AMENDMENT OF SOLICITATION

1. AMENDMENT/MODIFICATION NO. 0001		2. EFFECTIVE DATE JAN 02, 2003	
3. ISSUED BY DEPARTMENT OF THE ARMY, BALTIMORE DISTRICT CORPS OF ENGINEERS P.O. BOX 1715 BALTIMORE, MARYLAND 21203-1715 CODE: _____

6. ACCOUNTING AND APPROPRIATION DATA (If required) ISLE OF WIGHT, SALTMARSH CREATION, PHASE I WORCESTER COUNTY, MARYLAND			
7. DESCRIPTION OF AMENDMENT/MODIFICATION (Organized by UCF section headings, including solicitation/contract subject matter where feasible.) (1) THE TIME AND DATE FOR RECEIVING BIDS FOR THIS PROJECT IS EXTENDED TO 2:00 PM, LOCAL TIME JAN 14, 2003. REVISE STANDARD FORM SF 1442, BLOCK 13A OF THE SOLICITATION TO REFLECT THIS CHANGE. <u>SPECIFICATIONS:</u> (2) <u>Section 01010, Paragraph 1.2.7:</u> Immediately after this paragraph insert the following new paragraph: "1.2.8 Sand (For Construction Purposes) Sand is not specified for this phase of the project. However, the sand specification for any imported material placed landward of the structures would be as follows (if the Contractor elects to place material for access purposes, or any other purpose) at no additional cost to the USACOE: "The Except as provided herein, all terms and condit

DETAIL 22 - SILT FENCE

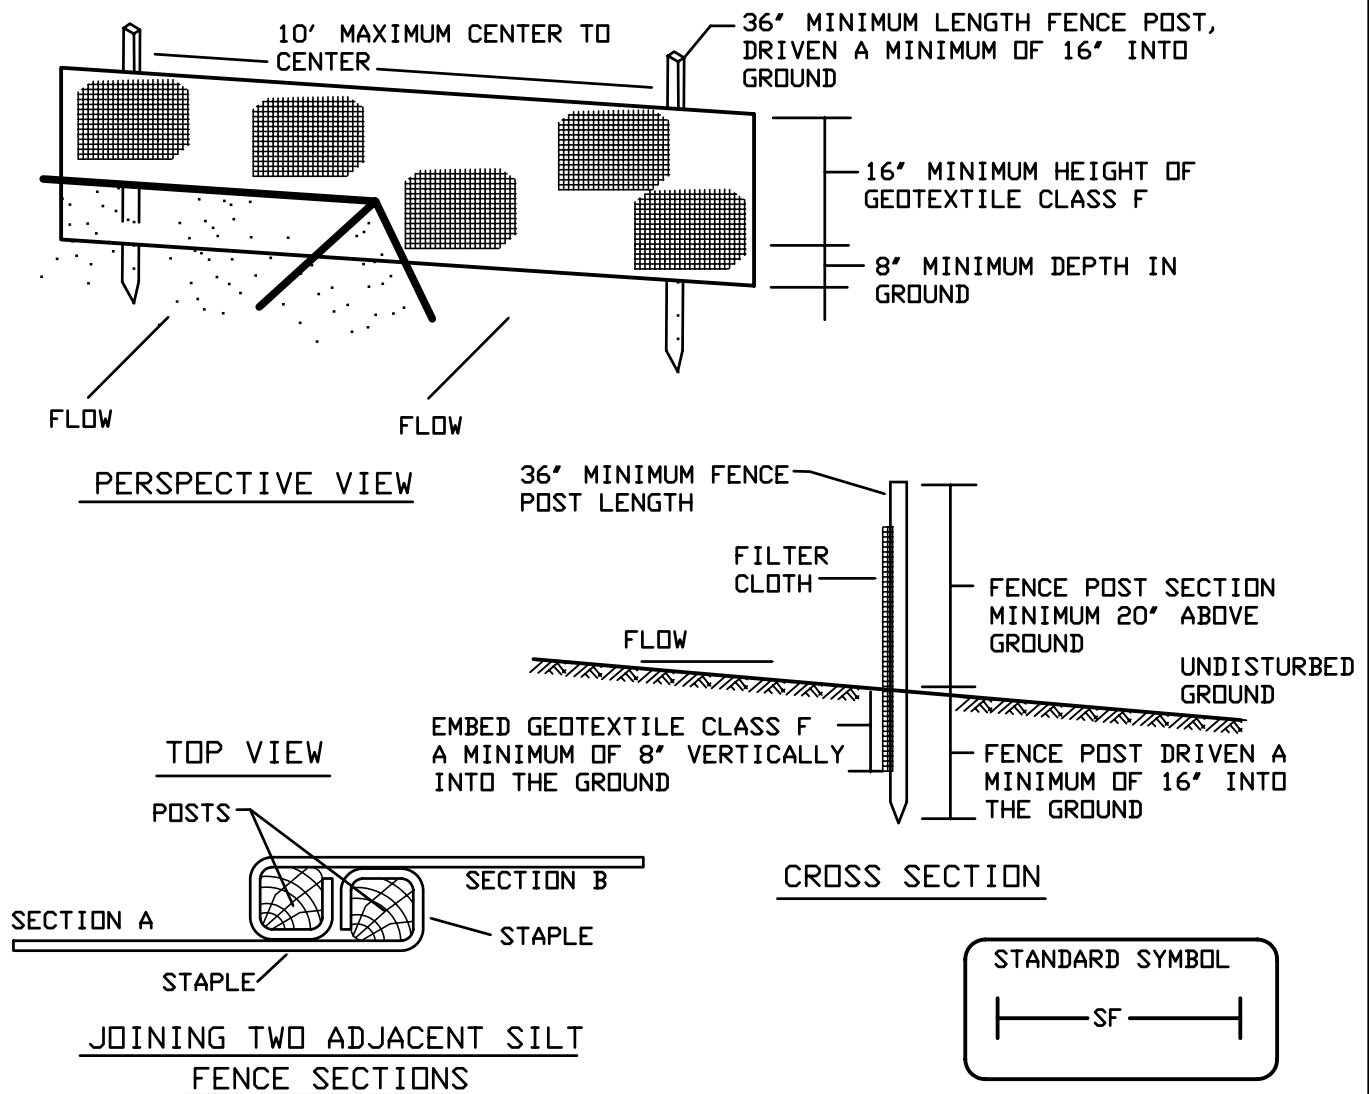
- (5) Sheet C-3: Replace silt fence detail with revised detail (Revision1.pdf).
- (6) Sheet C-4: Add table (Revision2.pdf) showing proposed elevations at various stations along the construction line.
- (7) Sheet C-7: Change note in Groin Section Detail A-A to read: "TOP ELEVATION VARIES FROM TOP OF REVETMENT (BY OTHERS) AT STA. 0+00 TO 4.0' MLLW AT STA. 1+66". See Revision3.pdf.
- (8) Attached to the end of this amendment are Contractor's Questions from Pre-Bid Conference dated 18 December 2002 and are for information only.

1. Fence posts shall be a minimum of 36' long driven 16' minimum into the ground. Wood posts shall be 1 1/2" x 1 1/2" square (minimum) cut, or 1 3/4" diameter (minimum) round and shall be of sound quality hardwood. Steel posts will be standard T or U section weighting not less than 1.00 pound per linear foot.

2. Geotextile shall be fastened securely to each fence post with wire ties or staples at top and mid-section and shall meet the following requirements for Geotextile Class F:

Tensile Strength	50 lbs/in (min.)	Test: MSMT 509
Tensile Modulus	20 lbs/in (min.)	Test: MSMT 509
Flow Rate	0.3 gal ft ² / minute (max.)	Test: MSMT 322
Filtering Efficiency	75% (min.)	Test: MSMT 322

3. Where ends of geotextile fabric come together, they shall be overlapped, folded and stapled to prevent sediment bypass.

4. Silt Fence shall be inspected after each rainfall event and maintained when bulges occur or when sediment accumulation reaches 50% of the fabric height.
